37/3-00X 500 Tulip Avenue Rev. R  
(Takoma Park Historic District)

**MEMORANDUM**

SUBJECT: Historic Area Work Permit

**HISTORIC PRESERVATION COMMISSION STAFF REPORT**

Changed Plan  
\* ← indicates change

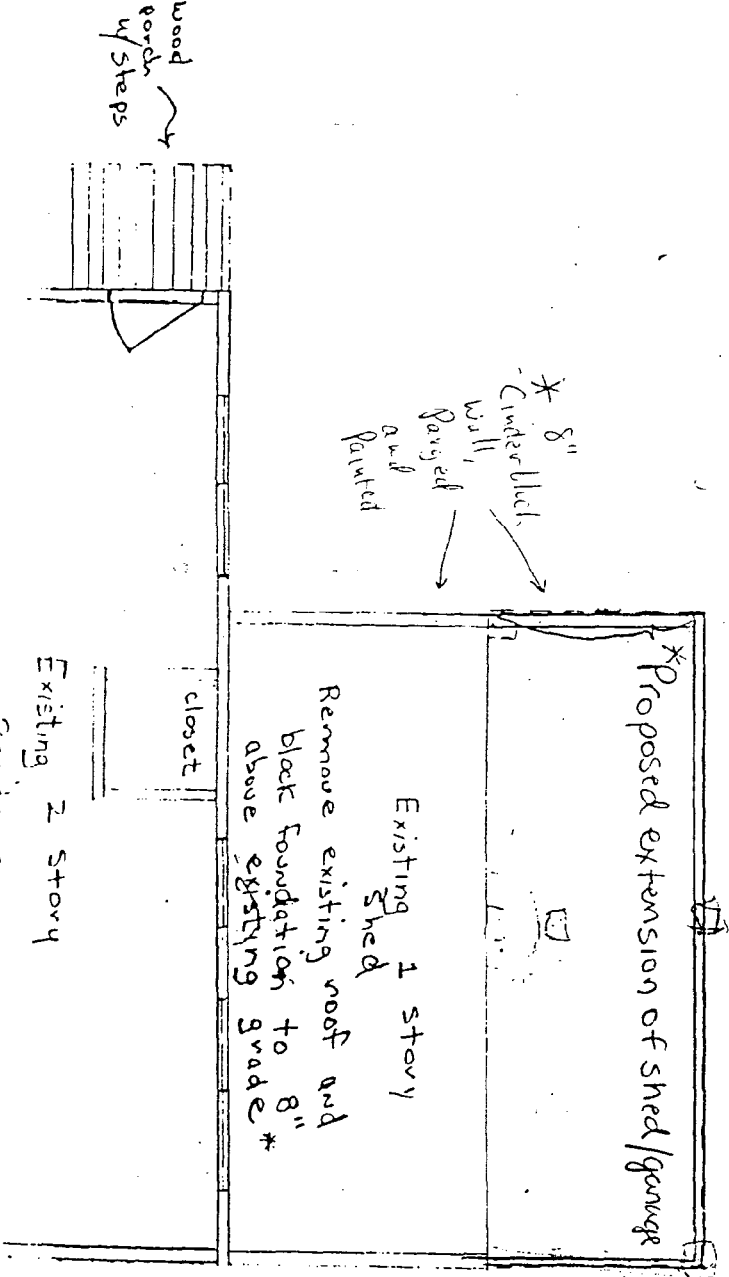
\* VERIFY EXISTING  
FOOTINGS WITH  
1.504 - 11.11.02

\*Proposed  
Change:  
Painted  
Hardi plank  
Siding  
w/5" lap

WEST ELEVATION

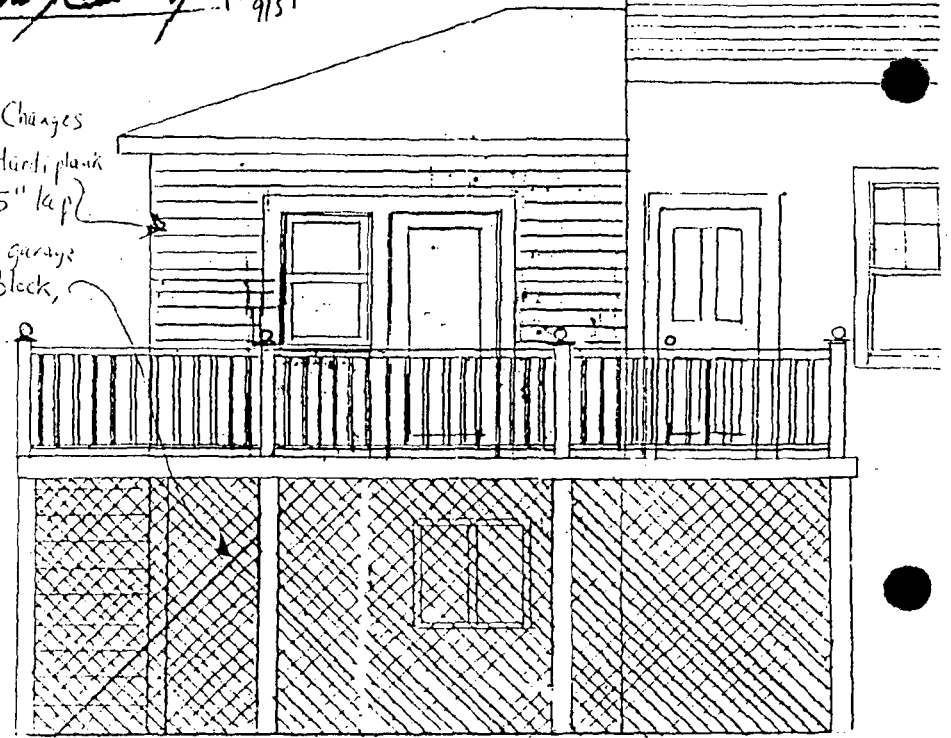
\* Proposed Changes

- 1. Painted Hardi-plank Siding 45" lap
- 2. Extend garage wall: 8' block, parged, and painted

Changed Plan  
\* ← indicates change

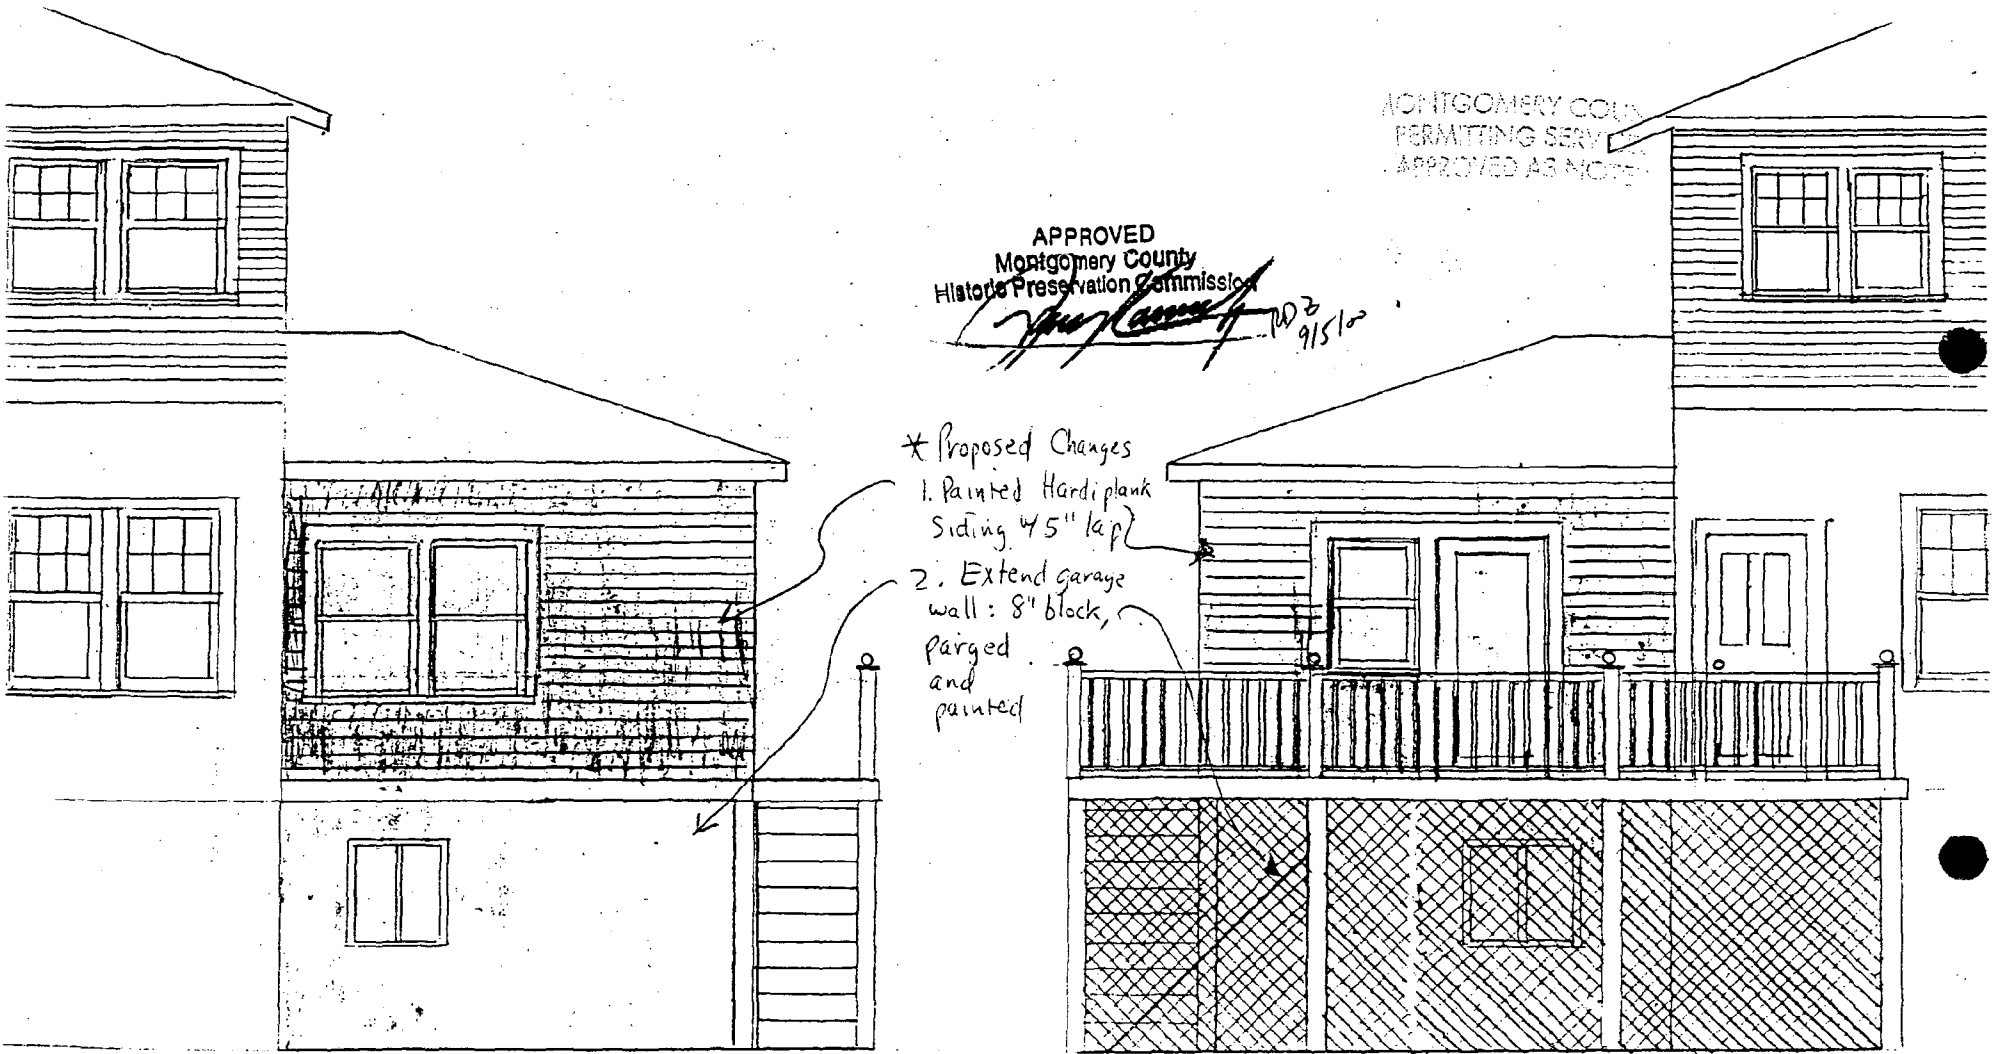
\* VERIFY EXISTING  
FOOTINGS WITH  
VISUAL SURVEY

\*Proposed  
Change:  
Painted  
Hardi plank  
Siding  
w/5" lap

WEST ELEVATION

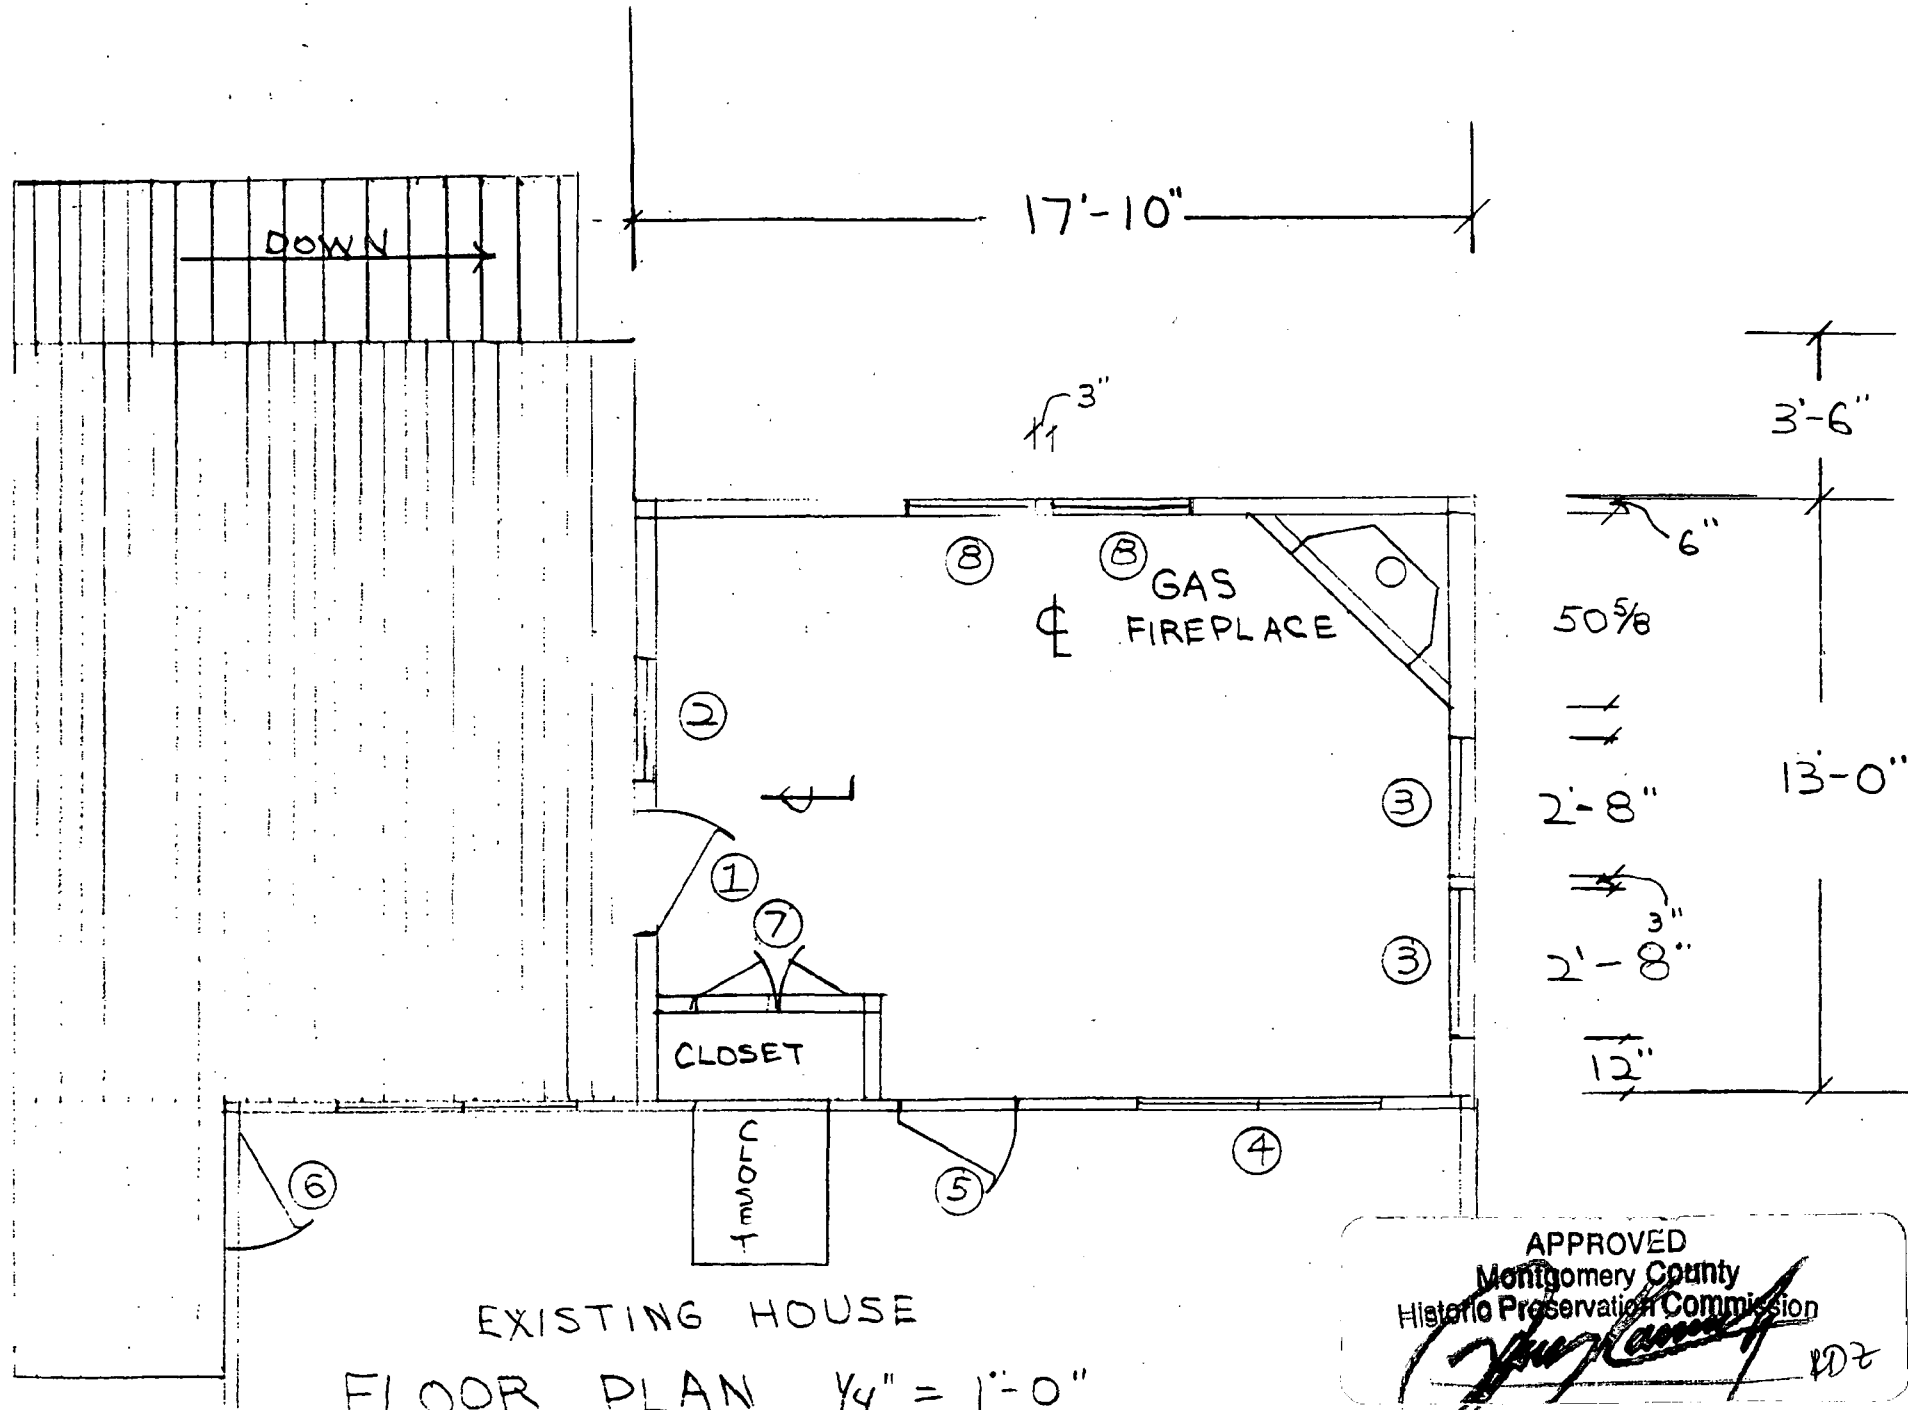
\* Proposed Changes

- 1. Painted Hardiplank Siding, 45" lap
- 2. Extend garage wall: 8" block, parge and painted

DEMOLITION PLAN

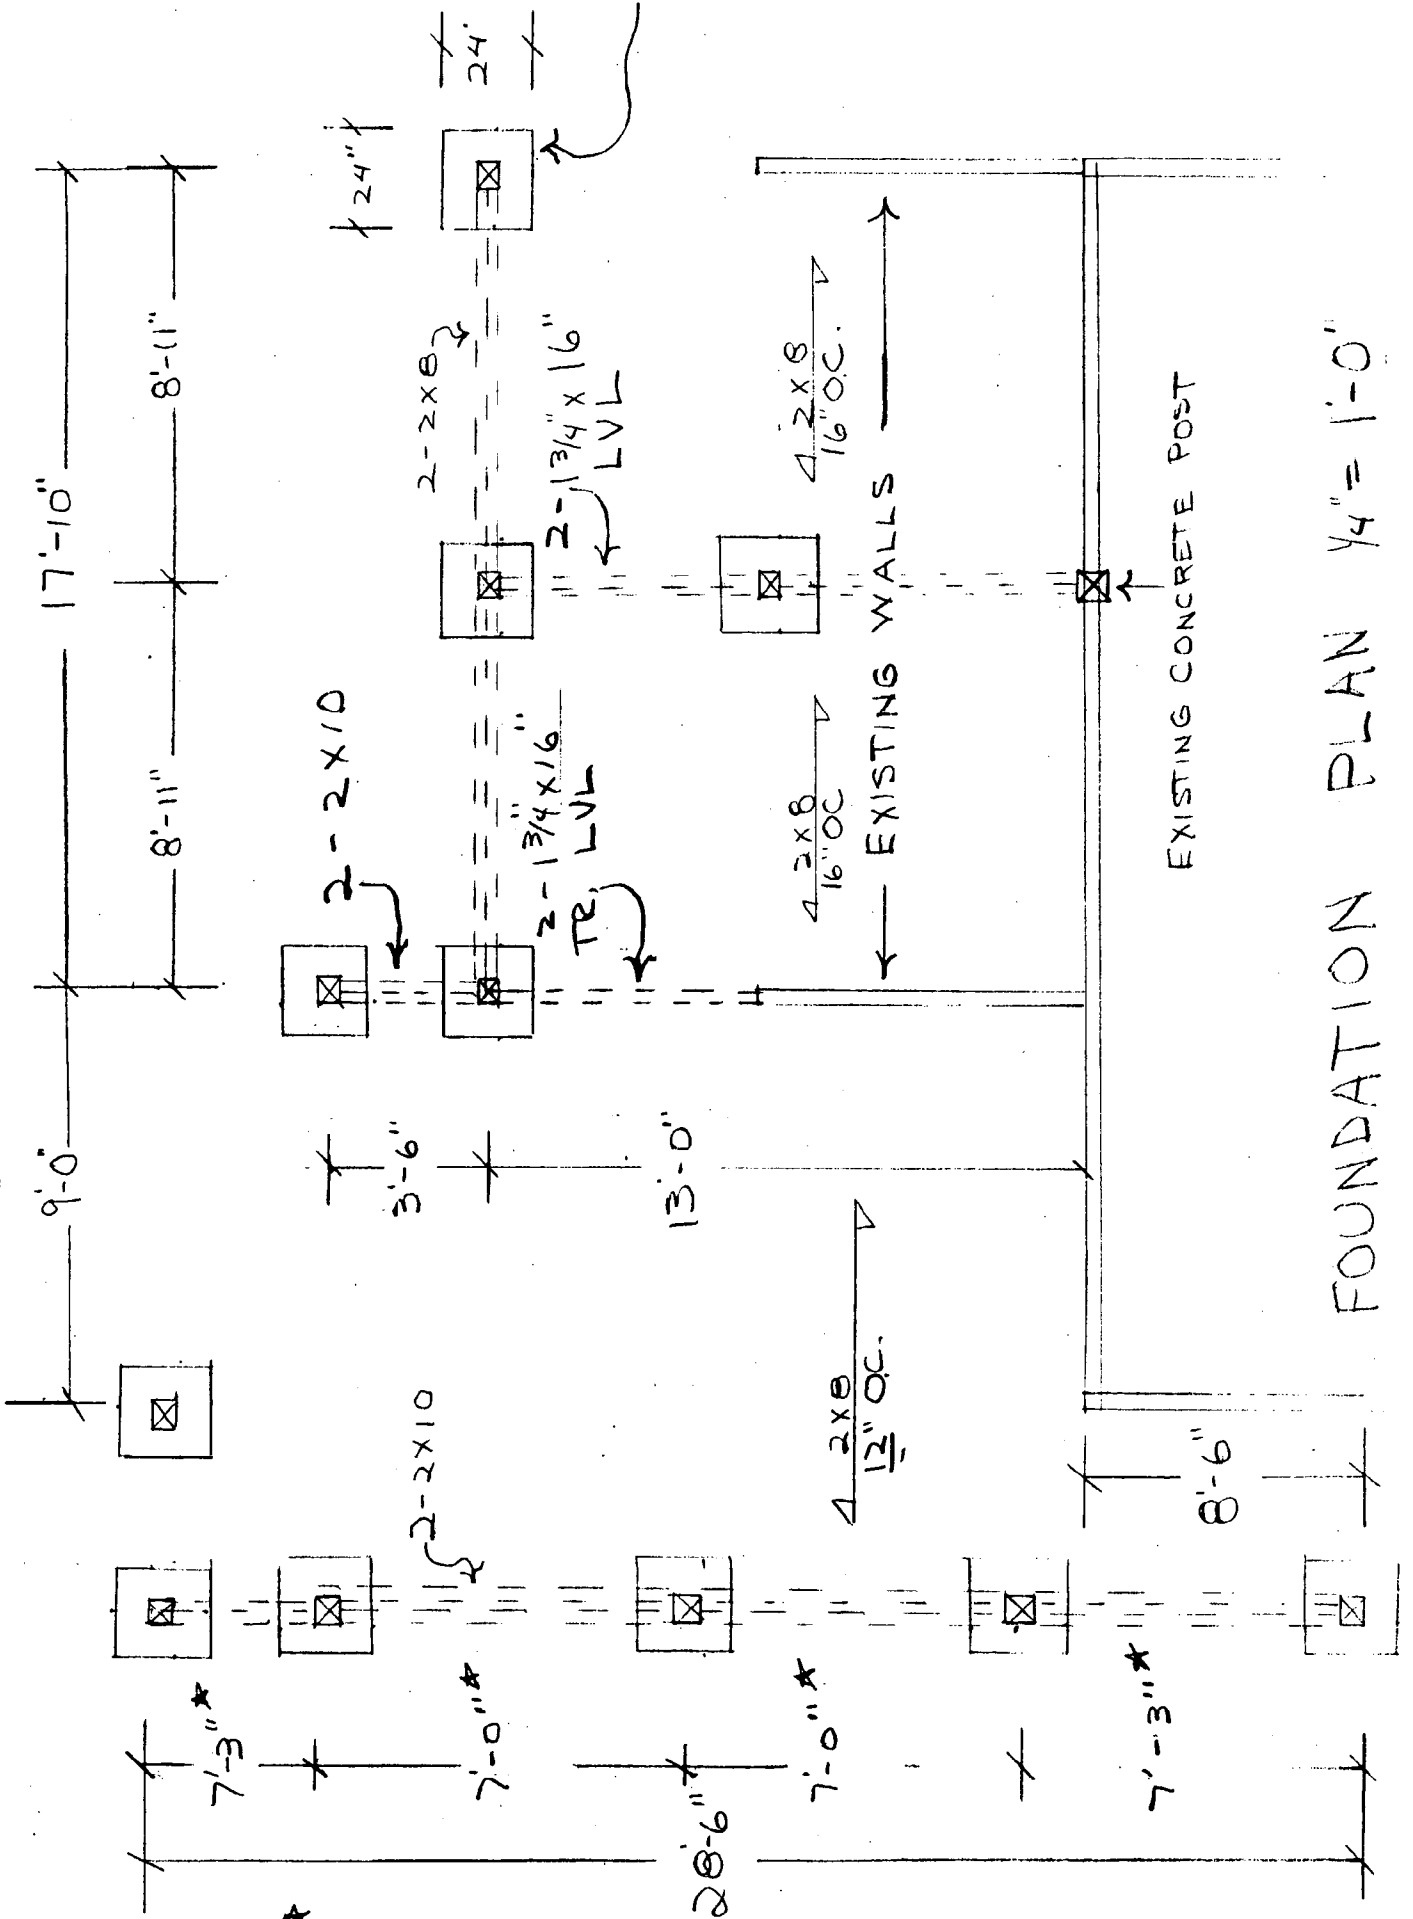
\* VERIFY EXISTING  
FOOTINGS WITH  
VISUAL INSPECTION
